# UNITED STATES PATENT AND TRADEMARK OFFICE

10/720,173

# Office Action Summary

## DETAILED ACTION

FIG. 1  
(PRIOR ART)

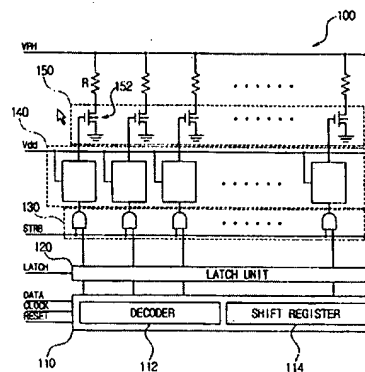
- {claim 1} An inkjet printer head driving apparatus having a plurality of heating elements and nozzles (figure 1, reference 100); a switching unit turning on and off each of the heating elements to heat ink corresponding to selected nozzles to eject the ink (figure 1, reference 150); a level shift unit having a level converter converting a potential level of a signal inputted therein into a predetermined potential level to drive the switching unit (figure 1, reference 140), a buffer to output the converted level of the signal (figure 2, reference 144), and a transient time extending part provided with at least one time extending element to extend by a predetermined time a transient time of the output potential level of the signal during which the potential level of the signal inputted from the level converter to the switching unit is converted from a first signal level to a second signal level and vice versa (figure 1-2, reference 140); a control unit receiving an external

data signal, decoding the received data signal, and outputting the decoded data signal as a nozzle selection signal to the level shift unit to select the selected nozzles corresponding to a to-be-recorded image from the nozzles (figure 1, reference 110)

- {claim 8} An inkjet printer head driving apparatus having a plurality of heating elements and nozzles (figure 1, reference 100); a control unit generating a control nozzle selection signal to select a heating element and a nozzle corresponding to an image to be printed (figure 1, reference 110); a level shift unit generating a first nozzle selection signal having a first transient time, during which a level of the first nozzle selection signal is changed between first and second levels, in response to the control nozzle selection signal, and generating a second nozzle selection signal having a second transient time extended by a period from the first transient time of the first nozzle selection signal (figure 1-2, reference 140); and a switching unit turning on and off the heating element according to the second nozzle selection signal (figure 1, reference 150)

- {claim 31} An inkjet head driving unit (figure 1); a control unit to generate a nozzle selection signal to select a nozzle having a heating element (figure 1, reference 110); a level shift unit to convert the nozzle selection signal to have a predetermined level to drive the heating element between a logic high and a logic low and having a buffer to output the converted nozzle selection signal (figure 2, reference 144), and one or more logic units to increase a time required to change the output nozzle selection signal between the logic high and the logic low (figure 1-2, reference 140); and a switching unit to turn the heating element on and off according to the output of the level shift unit (figure 1, reference 150)
